**From:** [Greaney, Kevin](#)  
**To:** [David Stoner](#); [James Gamertsfelder](#); [Marty Stewart](#)  
**Cc:** [Egetter, David](#); [eric.aufderhaar@ncdenr.gov](mailto:eric.aufderhaar@ncdenr.gov); [Bentkowski, Ben](#); [Hunneke, William F](#); [Chan, Sydney](#)  
**Subject:** EPA Comments on Vapor Intrusion Workplan  
**Date:** Friday, October 15, 2021 3:05:00 PM  
**Attachments:** [EPA Comments - Conbraco Vapor Intrusion Workplan - 2021-10-15.pdf](#)

See attached VI workplan comments from EPA and NCDEQ. The VI workplan is approved. All comments must be addressed in the VI sampling report. Please contact me by email or phone if you have any questions.

**FINAL VAPOR INTRUSION SAMPLING WORKPLAN  
CONBRACO INDUSTRIES, INC. - MATTHEWS FACILITY  
MATTHEWS, MECKLENBURG COUNTY,  
NORTH CAROLINA**

PROPOSED INDOOR AIR AND SUB-SLAB  
VAPOR INTRUSION SAMPLING POINTS

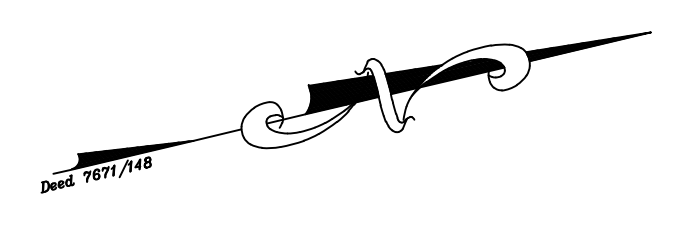
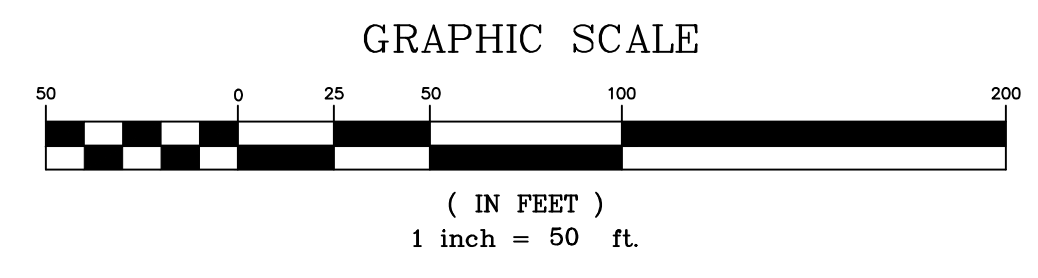
**Section 3.2, page 8** – *The Vapor Intrusion Workplan states ““Background” sub-slab air sample (SS-20) will be collected under the asphalt paving.” As shared in previous comments and discussed in several teleconferences, the EPA will not accept any location on Conbraco property as a true background sample. The location recommended for background sampling is likely also contaminated. The EPA recommends identifying a location that is least likely to be impacted and will be considered for comparison purposes only. No samples collected will be considered background.*
